## CITY OF SAN ANTONIO POADP APPLICATION

RE: Fischer 61 Acre Tract Subdivision POADP #457

POADP # 457-A

F.C.S. Fischer 61 Acre Tract (POADP 457-A)

POADP NO. <u>457-</u>4 (PREVIOUSLY EXPIRED POADP #457)

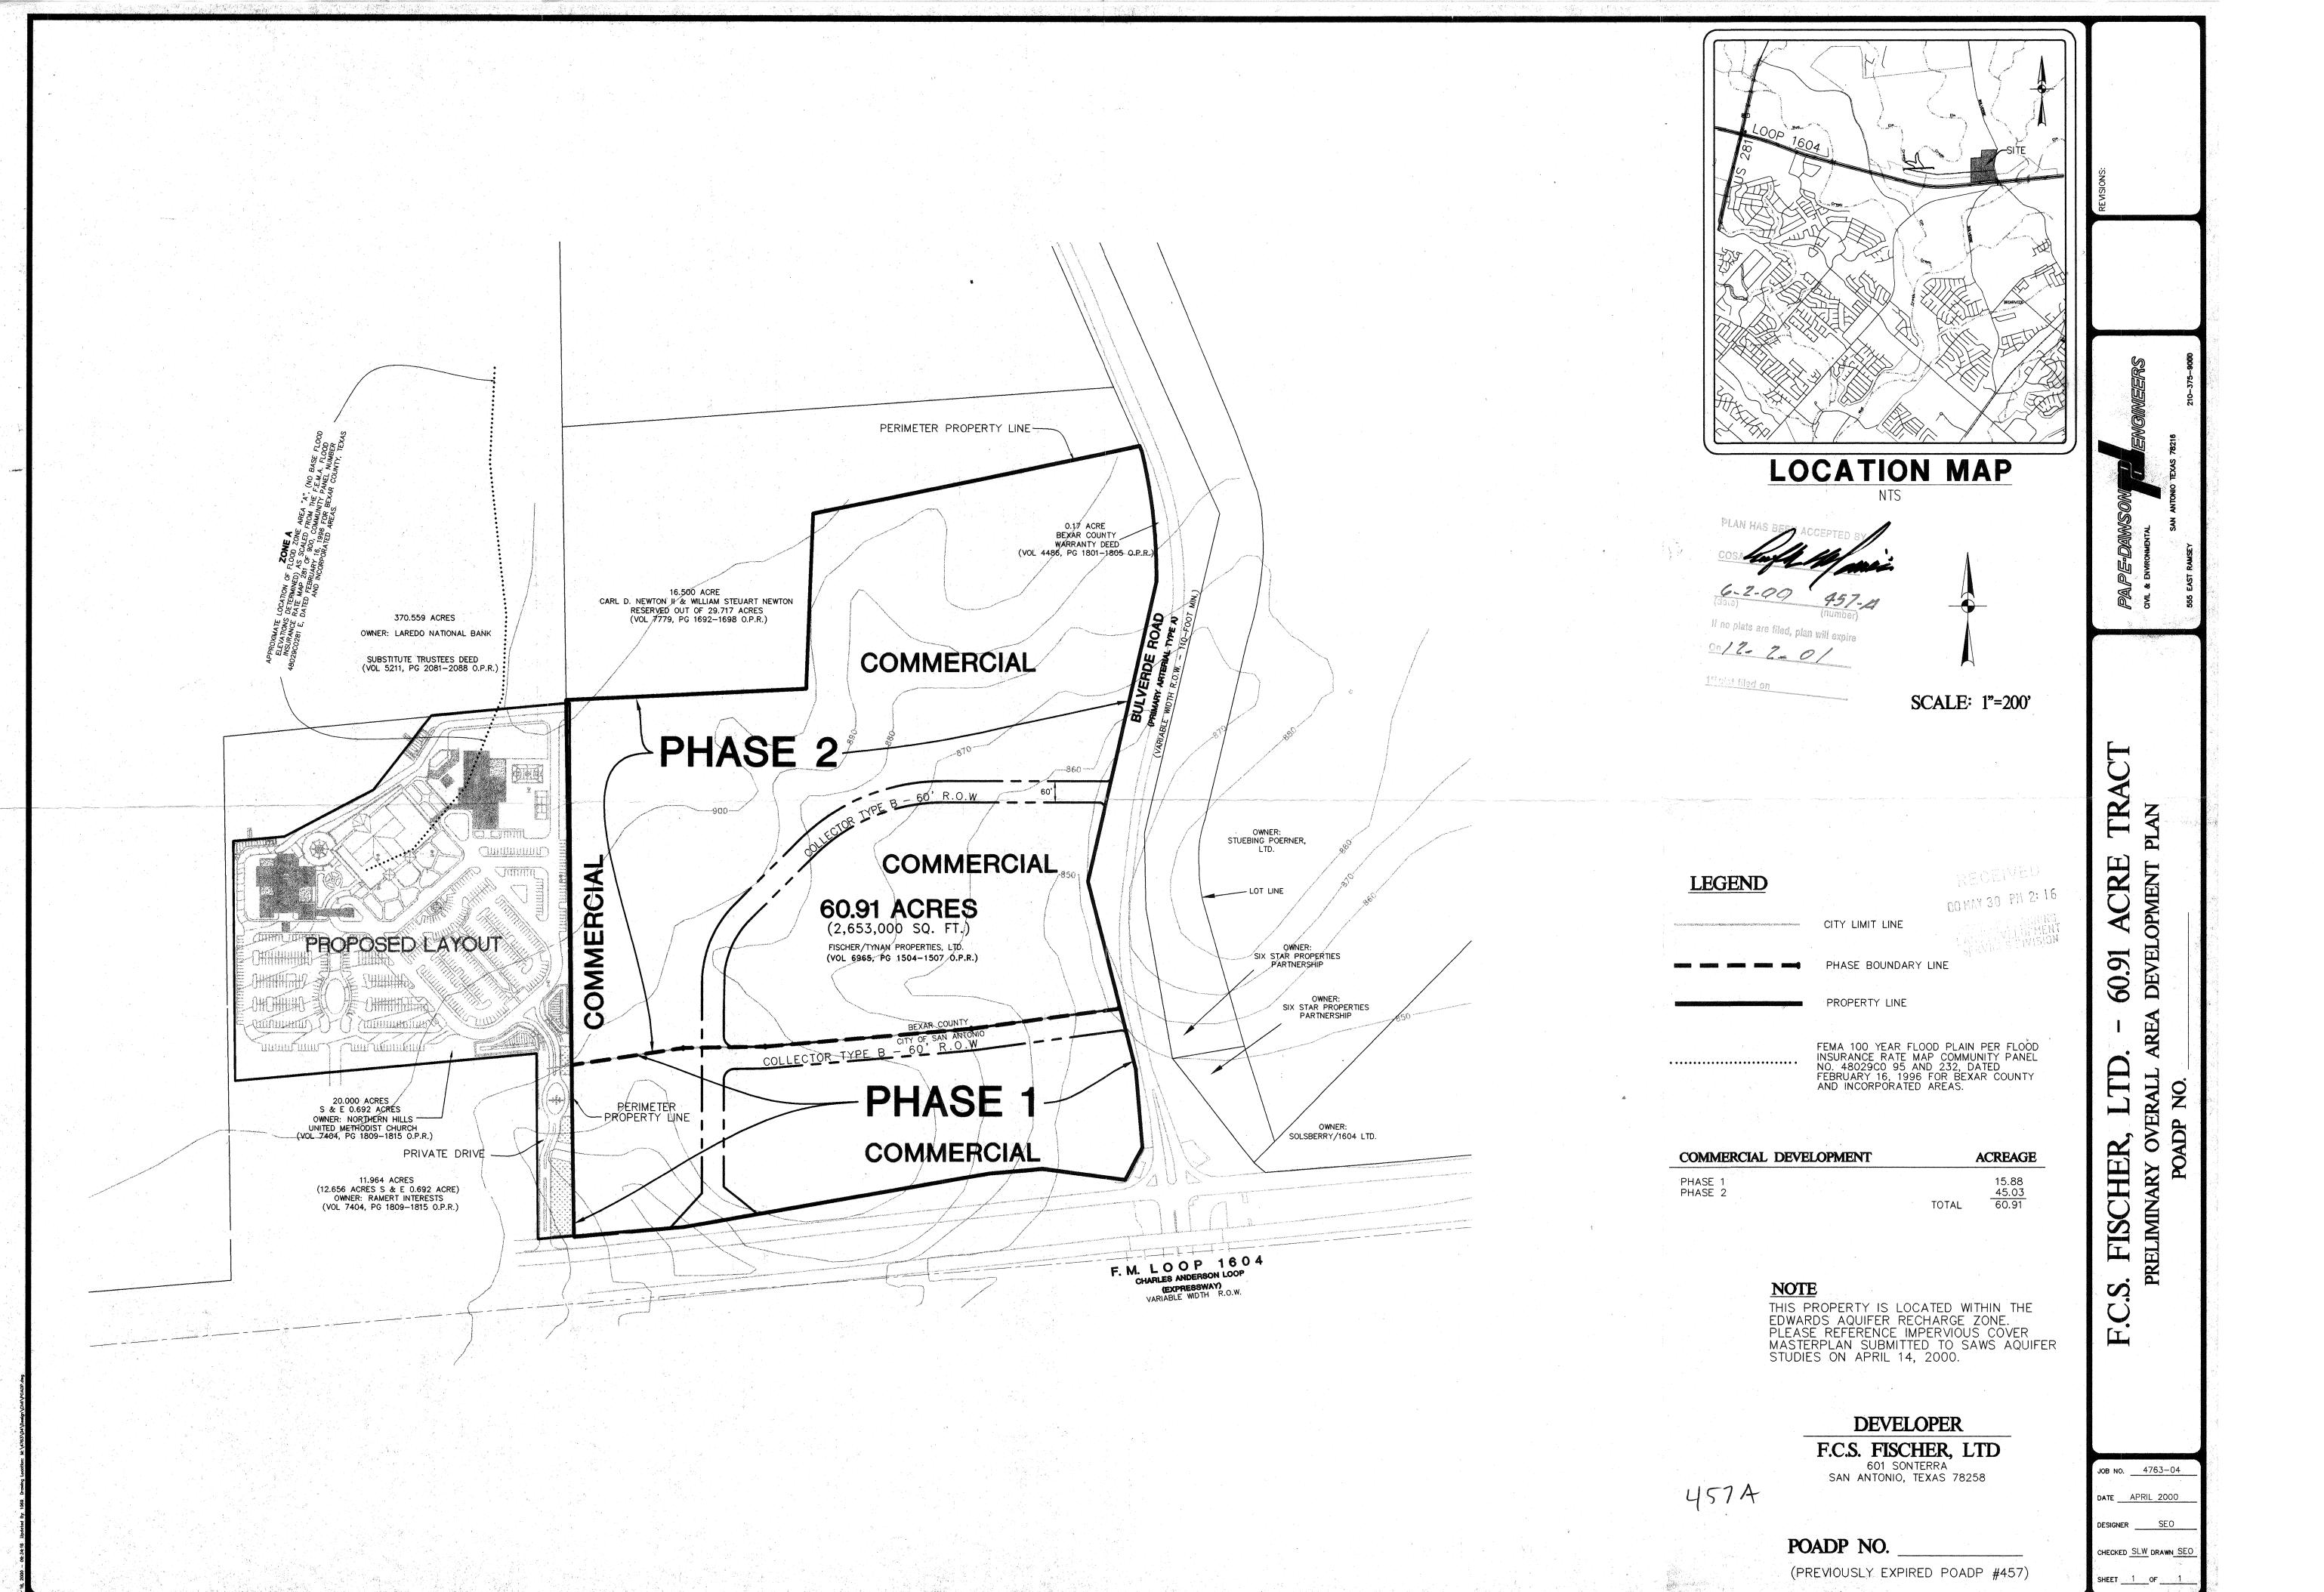
- Based on the topography, a Flood Plain Study and drainage review will probably be required during the platting process. Bexar County Public Works may require base flood elevations at the plat level.

- In consideration of public safety and convenience, excessive grades by reason of topography should be avoided in street layouts and arrangements.
- This development will probably need to conform to requirements associated with development over the Edwards Aquifer. For additional information about these requirements you can contact SAWS at 704-7305.

- Access and R.O.W. issues along State facilities will need to be resolved with the Texas Department of Transportation (TXDOT). For information about these requirements you can contact TXDOT at 615-5814.

- 1.) Sec. 35-2075 Information Required
- (a) Perimeter property lines. Are not clear and distinct.
- (e) Existing and proposed circulation system of collector, arterial, and local type B street and their relationship to any adjacent major thoroughfares; and any proposed alternative pedestrian circulation system. Were not provided.

- (h) Existing adjacent or perimeter streets (including right-of-way widths), intersections, and developments. Were not provided.
- 2.) Sec. 35-4110 Access From Major Thoroughfares

- (d) Paragh, (2) The resulting additional ingress and egress of vehicles Will seriously disrupt the flow of traffic on the thoroughfare. A 1'-non accesses esm't will be required on the properties adjacent to the proposed collectors.

- 3.) Access needs to be provided to the adjoining properties for connectivity.
- 4.) The digital file was missing from submittal.
- 5.) we need a Tx-Dot letter.

- 6.) Reference to the exist. P.O.A.D.P. # 457 was not made in the application, please correct the application and resubmit.

- On the attached revised POADP, we have made the perimeter boundary clear and distinct.
- The proposed circulation system was provided on the previously submitted 1.(e)POADP.

- The existing adjacent perimeter streets were included in the original submittal of 1.(h)the POADP including right-of-way widths. However, to clarify this, we have indicated the 1604 current configuration, the proposed adjacent church layout and graphically shown the right-of-way widths on the attached revised POADP.

- The collector streets that are proposed on this POADP are to serve the proposed commercial uses within this development. A 1-foot non-access easement which restricts access from this property to the collector streets will not be provided.

- Please note that Section 35-4110 of the code refers to major thoroughfares and not collectors and paragraph (d)(2) references under what conditions the Director of Public Works can grant "additional points of access" not prevent access.

- This development is intended to be self sufficient commercial use with no-through 3. public traffic from adjoining property.

- 4. We have provided a digital file of the revised POADP.
- 5. Although we are communicating with TxDOT, the current UDC does not require a letter from TxDOT for POADP approval.
- 6. The revised POADP and application now reflects the existence of the previously approved POADP No. 457.
